Warranty Bulletin**95-10**Date: **April 1995**Section: **16**Subject: **Transversal and Longitudinal Radius Rod**

Model	VIN
H3-41 coach, H3-45 coach, and H3-45 VIP converted coach shell	All up to 2P9V33493S1001129 inclusively

FIGURE 1

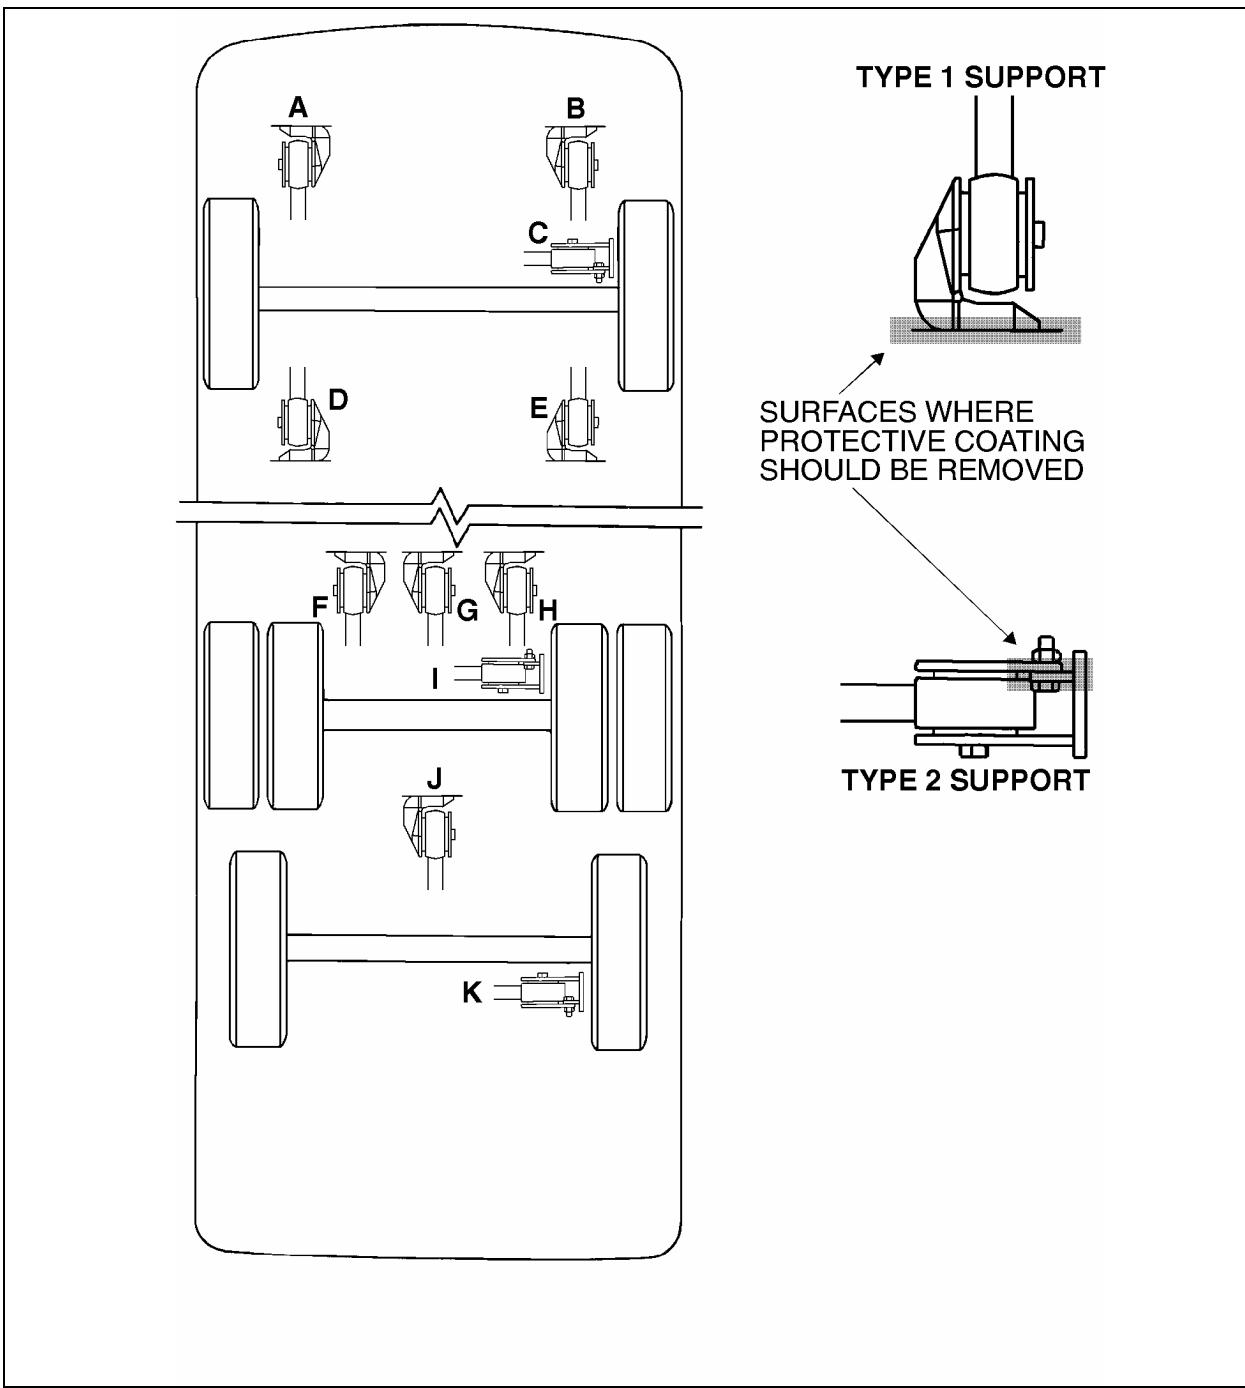
Prévost Car Inc engineering department has found that, on H3-41, H3-45 and H3-45 VIP vehicles, the protective coating applied on the subframe can form a cushion between subframe and radius rod support that, in extreme conditions, can lead to loosening of bolts. Therefore, you must dismantle these supports to remove the protective coating, as per the following procedure.

Type 1 Support (Fig. 1: **A, B, D, E, F, G, H, J**):

1. Unscrew the two bolts and nuts (on **F** and **G** support, one of the nut is accessible from last baggage compartment) retaining support on subframe.
2. Scrape off protective coating down to bare metal on both contacting surfaces (subframe and support).

3. Replace support, apply oil on threads of bolts, and torque bolts to 110-130 lbf·ft lubricated (150-175 N·m lubricated).

FIGURE 2

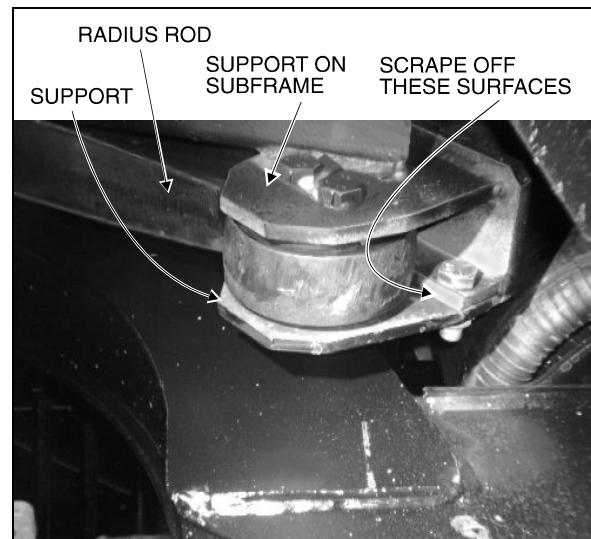
Type 2 Support (Fig. 1: C, I, K):

1. Flatten tab washer and unscrew bolts. Unscrew the two bolts and nuts retaining radius rod support and remove radius rod.
2. Scrape off protective coating down to bare metal on both contacting surfaces (support and support on subframe (Fig. 2)).

3. Replace support, radius rod and a new tab washer, apply oil on threads of bolts, and torque bolts to 110-130 lbf·ft lubricated (150-175 N·m lubricated). Fold tab washer over nuts.
